Job Code:	M920031 – 26-004	Product:	Lineage Series VP
Date:	5/20/2026	Repair Time:	0.2 h

This bulletin describes the procedure to install a Grand Design RV – supplied diode into the water pump control circuit of the Firefly Emprise electrical system on affected ProMaster LVP units. The diode prevents excessive current in the water pump control circuit that can damage the Firefly circuit board.

Fig. 3 — Supplied diode with Wago connector — locking levers open.

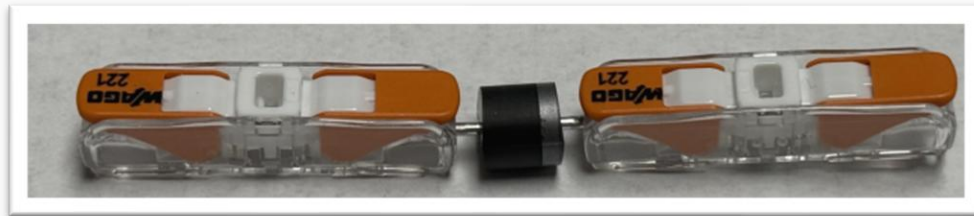
Step 5 – Take the Grand Design RV-supplied diode with the Wago connector and open the locking levers.

Step 6 — Insert one stripped wire end into each end of the Wago connector, then close the locking levers.

Diode orientation is critical. The line marked on the diode must face AWAY from the Firefly electrical board. Installing the diode backwards will prevent the water pump from operating.
